### ADDENDUM NO. 3

Date: April 27, 2021  
Project: Red Rocks Dialysis  
Owner: DaVita  
Architect: Searer, Robbins & Stephens, Inc.  
1730 E. Northern Avenue, Suite 124  
Phoenix, Arizona 85020

Architect's Project #: 2038

SHEET NO.  
**E-300**

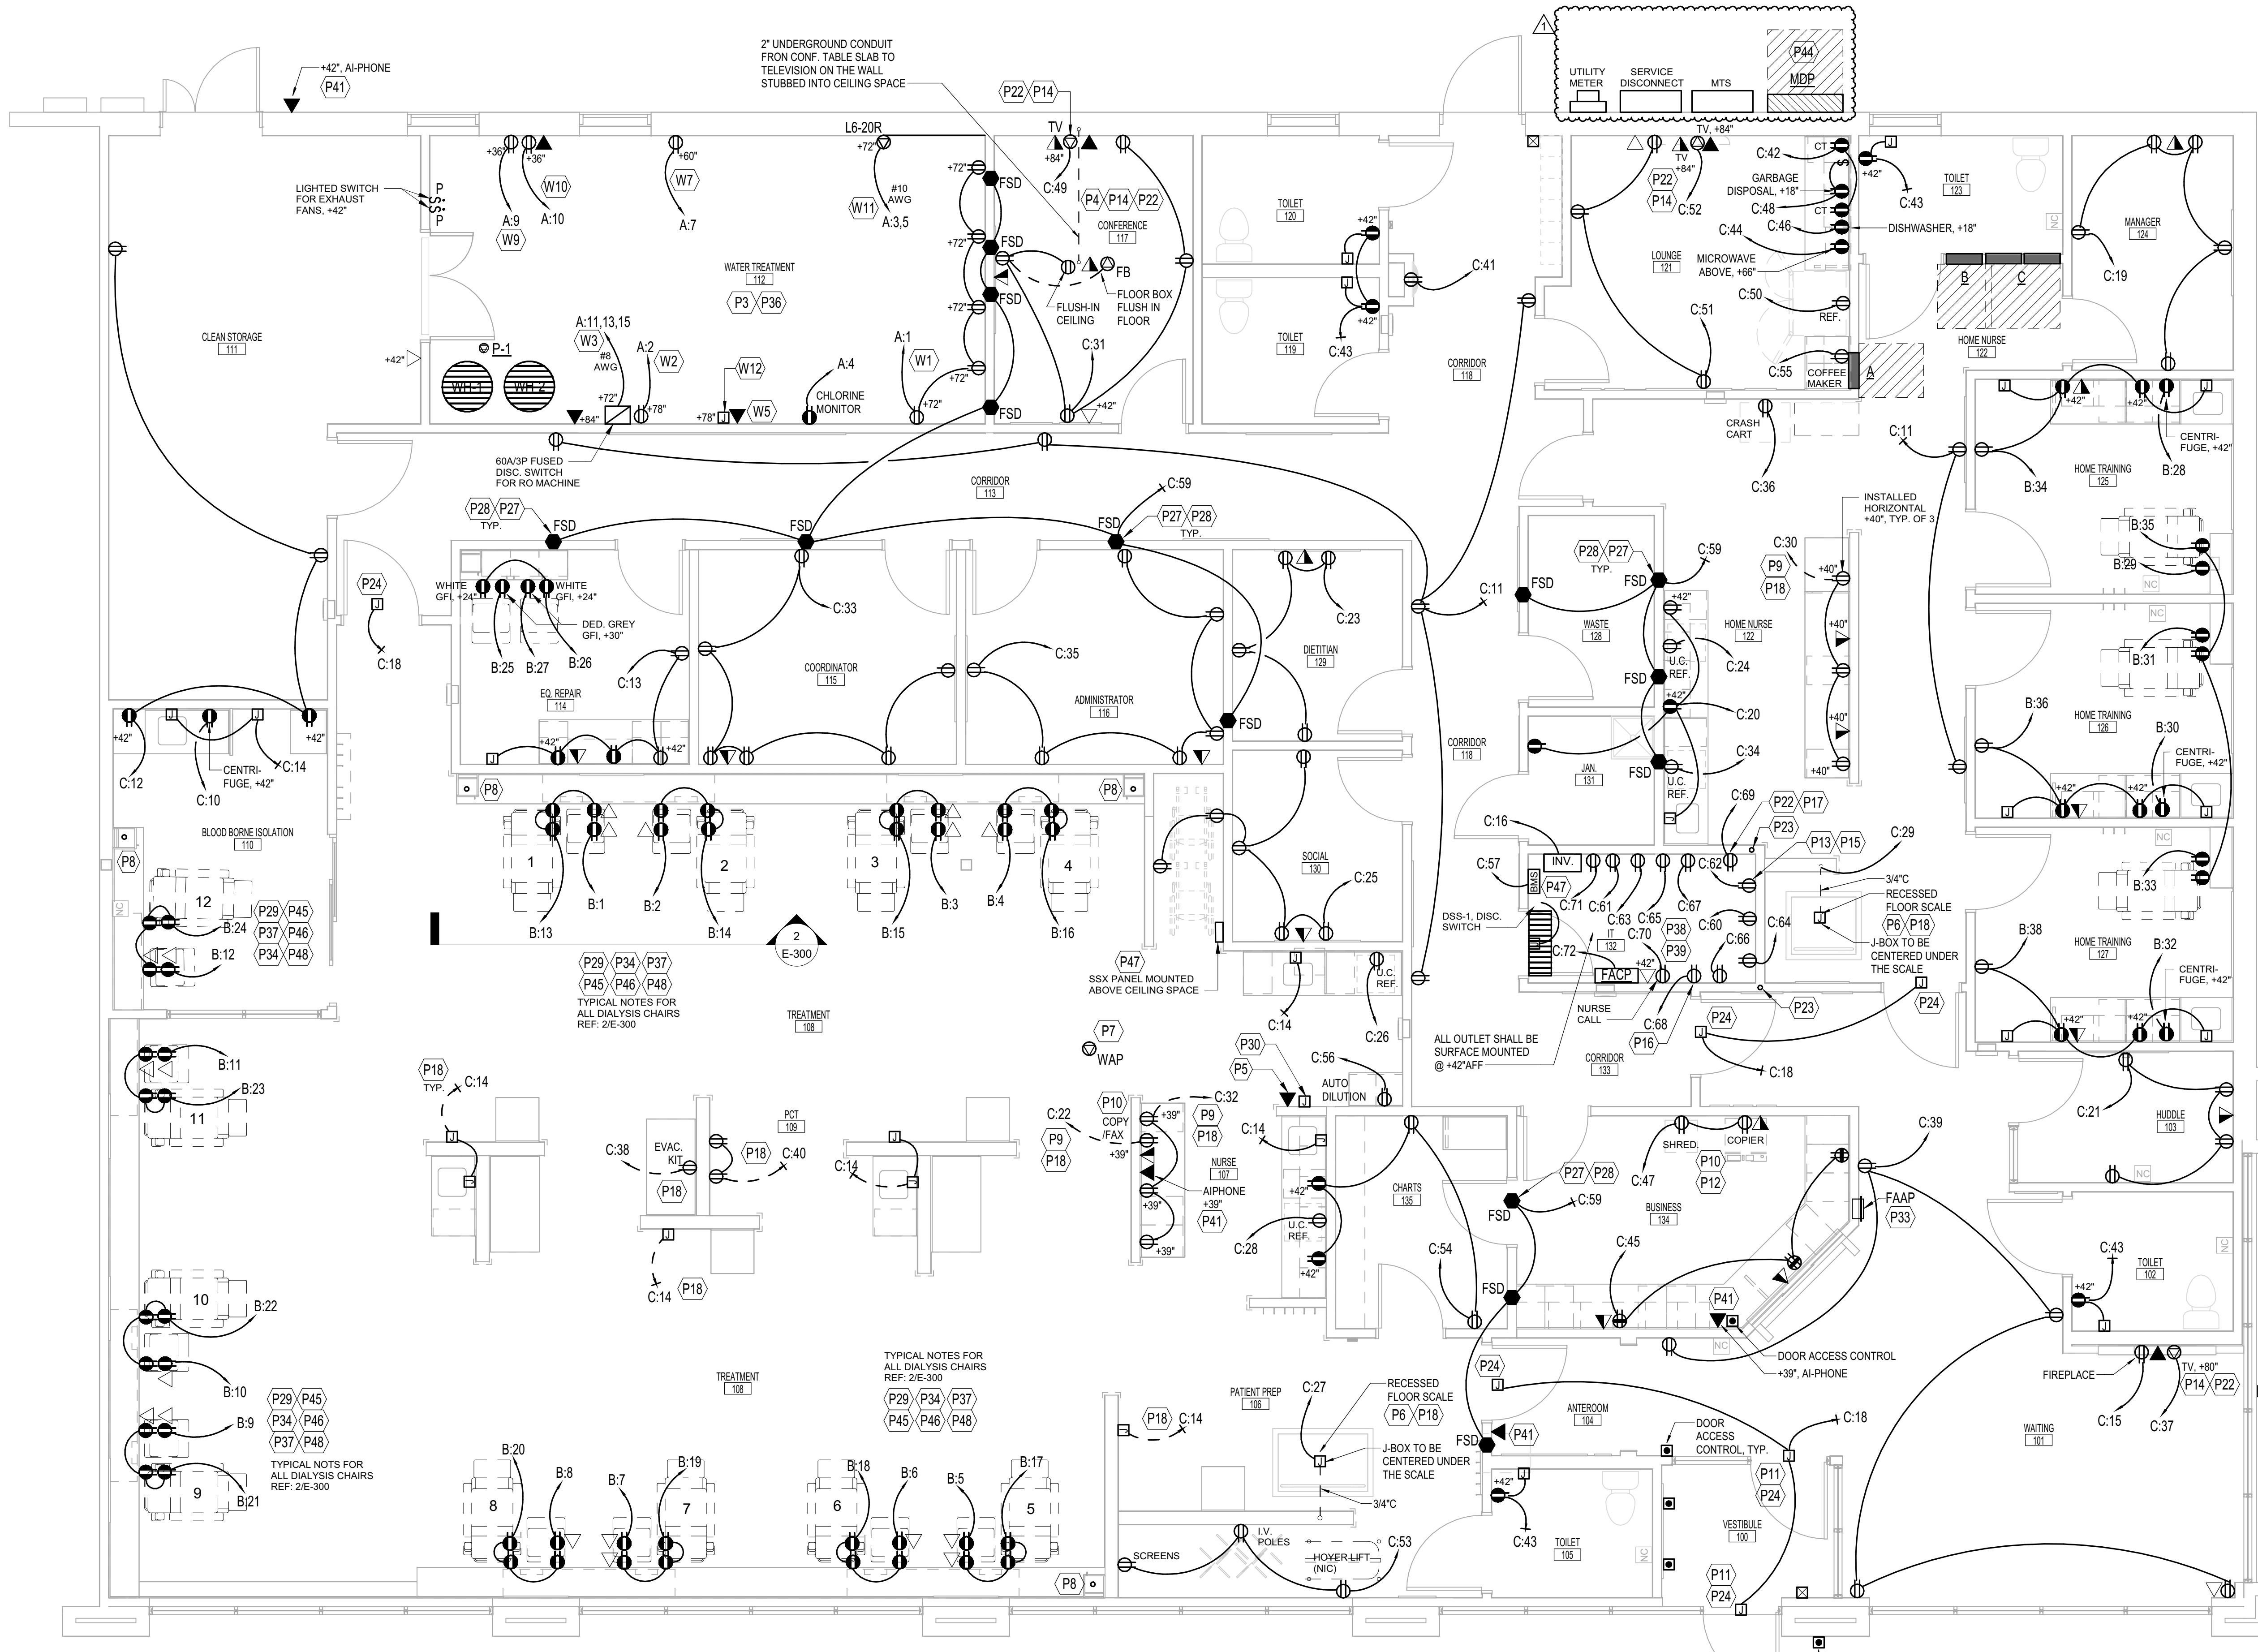
1. Add disconnect switch to electrical service per attached revised sheets E-300 and E-400, with clouds and delta one dated 04-27-21.
2. Clarification: Landlord is NOT responsible for installing the new 600Amp underground feeder from transformer.
